### **AMENDMENTS TO THE DRAWINGS**

EDWIN et al.  
Appl. No. 10/507,493  
June 30, 2006

Fig 1

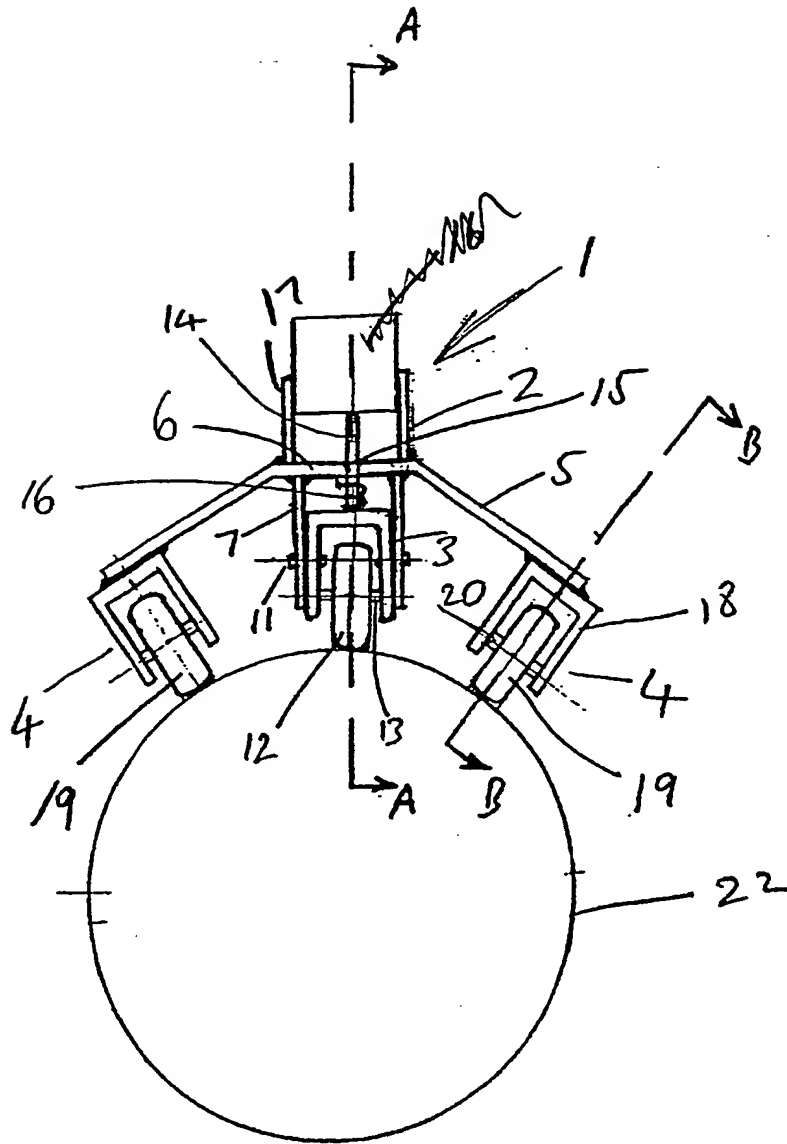
The attached sheet of drawings includes changes to Fig. 1. This sheet, which includes Fig. 1, replaces the original sheet including Fig. 1. In Figure 1, repeated reference numeral 16 has been deleted.

FIG. 1 has been amended to delete the repeated use of numeral ‘16.’ An annotated drawing sheet and a replacement drawing sheet are attached. Withdrawal of the objection is requested.
